Access Compliance Report

Public Rights-of-Way

(Curb Ramps)

Intersection ID: 2891	Main Street: BEAROAK_LN	Cross Street: RIDGEFIELD_DR	Location:	N
ADA ID: 5294A8B538B1	Ramp Type: Perp	Initial Pass/Fail: Fail	Overall Compliance: No	Severity Score: 8.75
Codes/Mitigation Info/Possible Solution		Field Measurements/Component Compliance

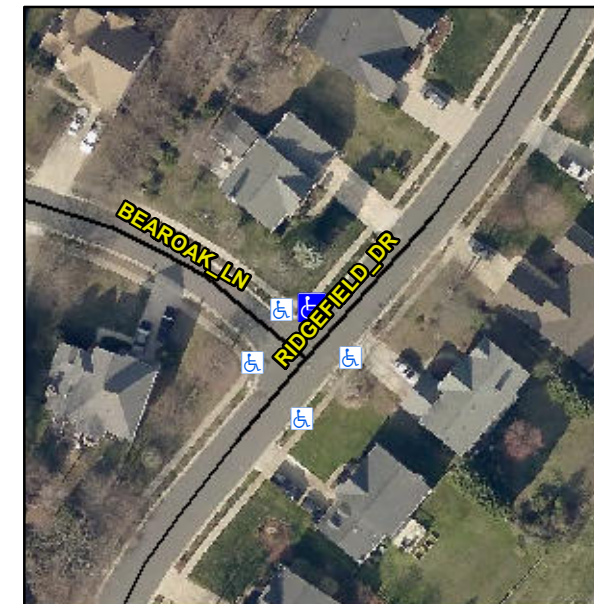
R304.5.1

Compliance	Description	Data	Compliance	Description	Data
N/A	Ramp Length (in)	47.0	Yes	Ramp Slope (%)	7.4
No	Ramp Width (in)	38.0	Yes	Ramp XSlope (%)	1.6
N/A	Flare Type LT	N/A	N/A	Flare Type RT	N/A
N/A	Flare Slope LT (%)	N/A	N/A	Flare Slope RT (%)	N/A
N/A	Flare Traversable LT?	N/A	N/A	Flare Traversable RT?	N/A
N/A	Landing Length (in)	N/A	N/A	DWS Provided?	N/A
N/A	Landing Width (in)	N/A	N/A	DWS Contrast?	N/A
N/A	Landing Slope (%)	N/A	N/A	DWS Length (in)	N/A
N/A	Landing X Slope (%)	N/A	N/A	DWS Full Width?	N/A
N/A	Landing Curb? (Y/N)	N/A	N/A	DWS Offset (in)	N/A
N/A	Shared Landing?	N/A			
N/A	Gutter Ponding?	N/A	N/A	Gutter Slope (%)	N/A
N/A	Gutter Lip Ht (in)	N/A	N/A	Gutter X Slope (%)	N/A
N/A	Painted X Walk1?	No	N/A	Painted X Walk2?	N/A
	X Walk 1 Direction	To SE		X Walk 2 Direction	N/A
N/A	X Walk 1 Width (in)	N/A	N/A	X Walk 2 Width (in)	N/A
	X Walk 1 Slope (%)	4.1		X Walk 2 Slope (%)	N/A
	X Walk 1 X Slope (%)	0.0		X Walk 2 X Slope (%)	N/A

Remove & Replace Entire Ramp.
